CATTARAUGUS COUNTY DEPARTMENT OF PUBLIC WORKS

ADDENDUM NO. 1

COUNTY ROAD 2 (Cottage Rd & Edwards Corners Rd) - RESURFACING FROM NASHVILLE ROAD TO STATE ROUTE 39

ADDENDUM DATE: 18 MAY 2023

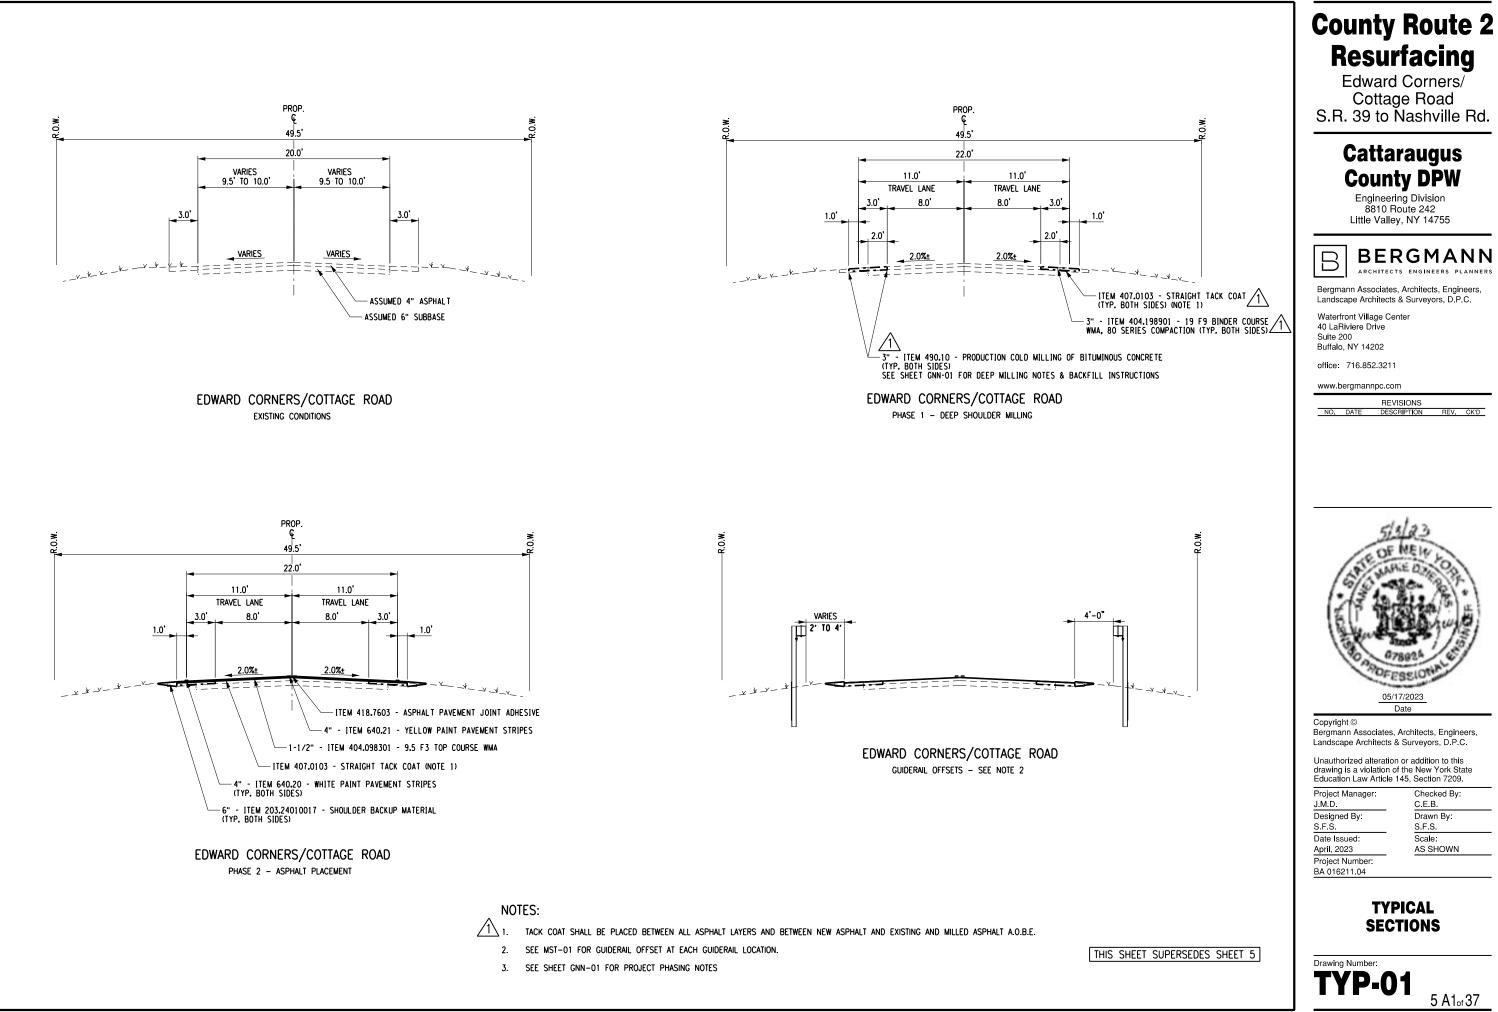
Plans: Sheet 6 superseded by Sheet 6 A1 of 37: TYP-01 changes made to typical sections, addition of binder layer over deep milled area
